工程指示 / 要求簡箋(E.I.)

工程指示編號：EI / 8571 / 24

工程名稱：將軍澳日出康城

工程項目：趙門 補 4 件玻璃 T2 T3 地盤執修用 (第 4 批)

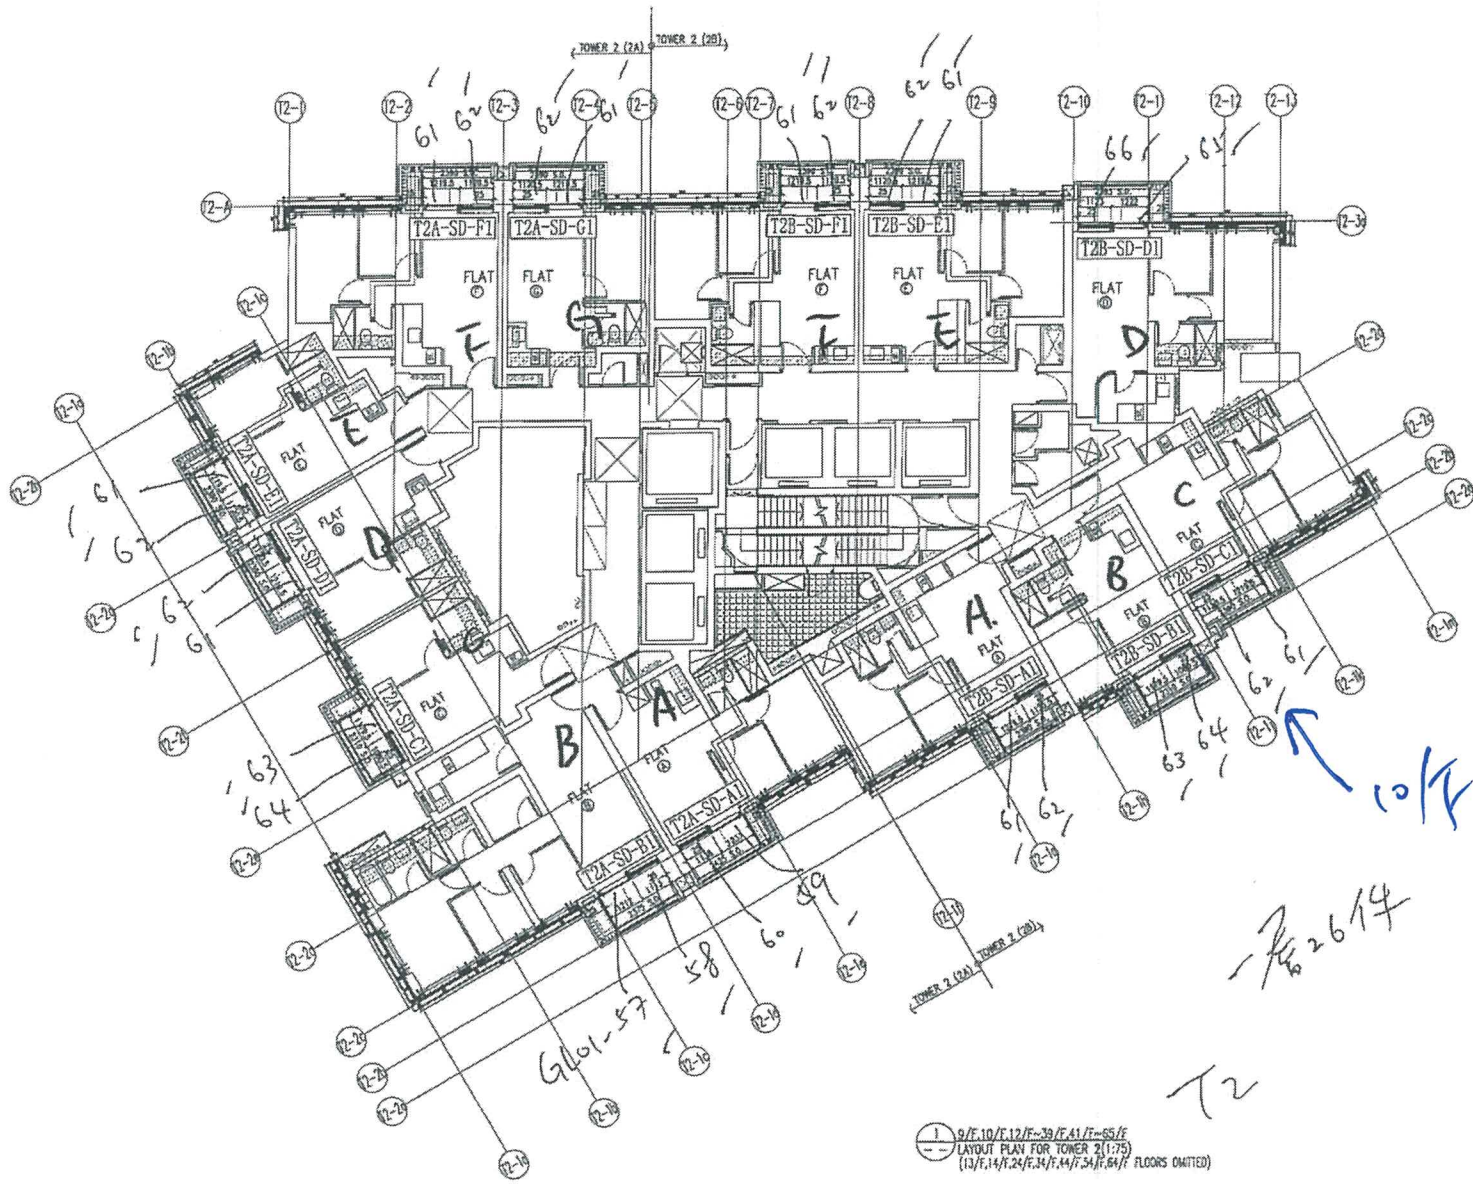
10/F BC 985x2525 補片 G101-62

48/AH G101-59

55/BE G101-62

51/F BB G101-63

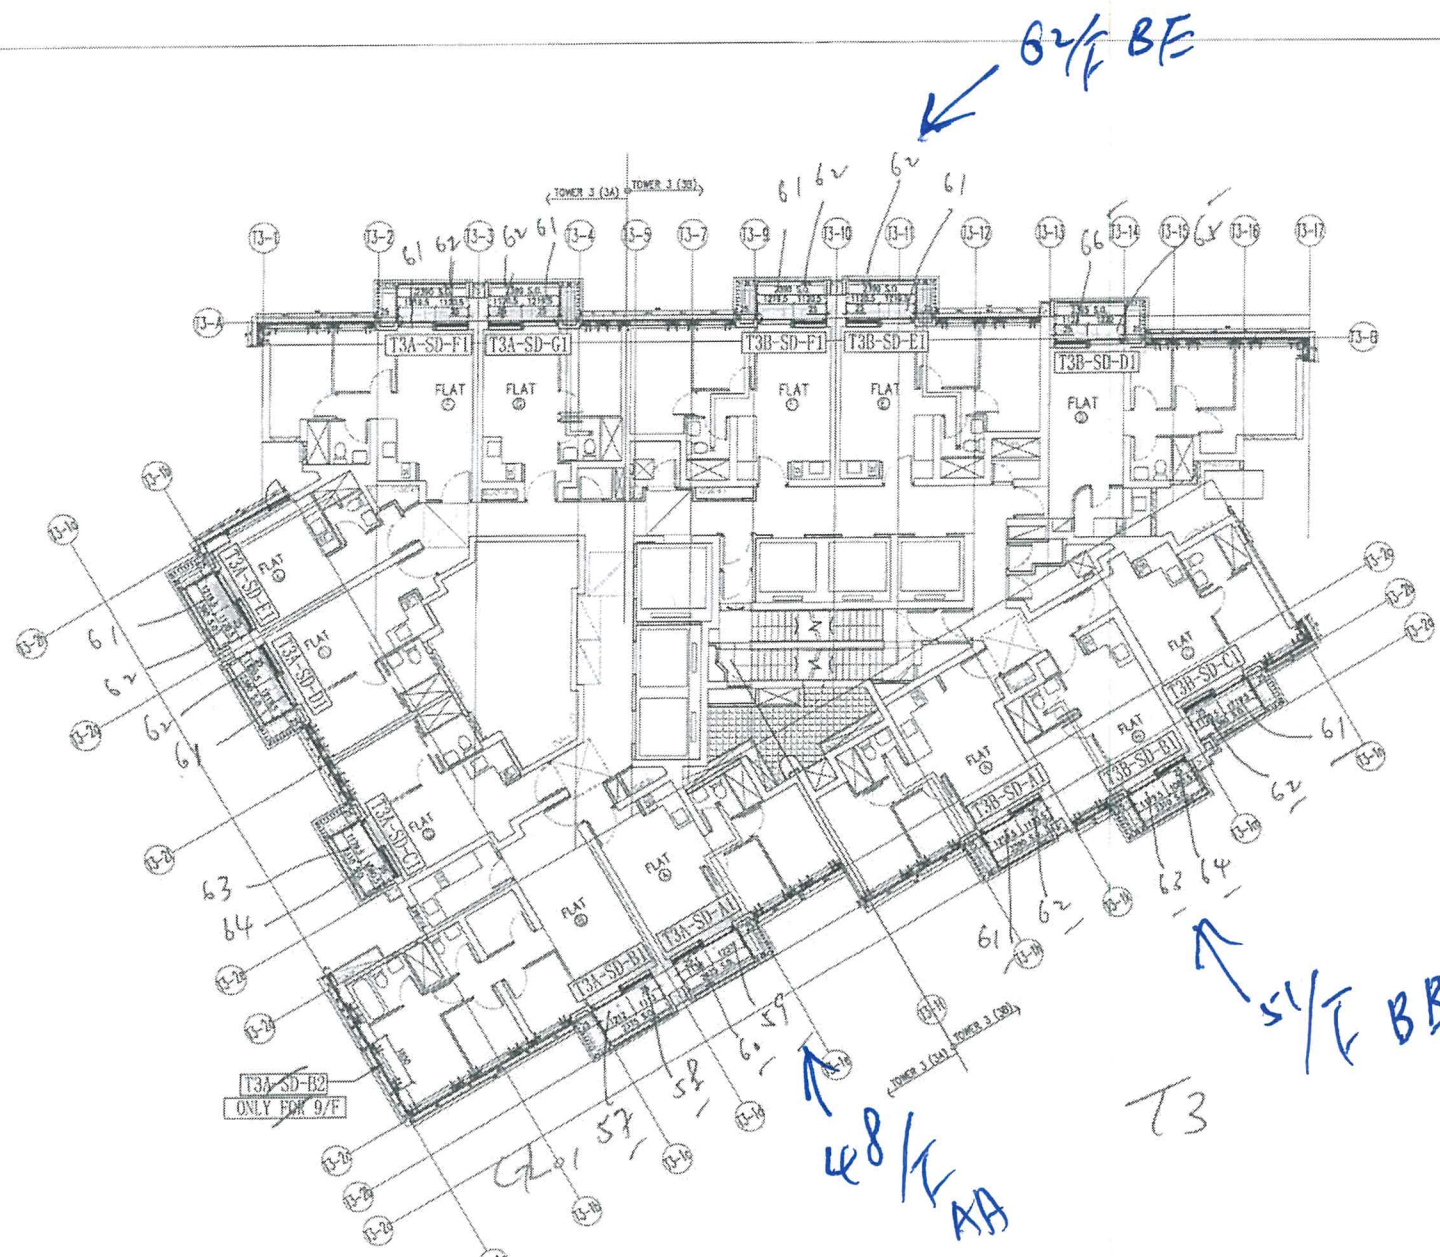
10/F BC 985x2525 补片 G(01-62)

48AA G(01-59 1025x2374 已包装 补片

55BE G(01-62 985x2525 已包装 补片

51/F BB G(01-63 977x2374 已包装 补片
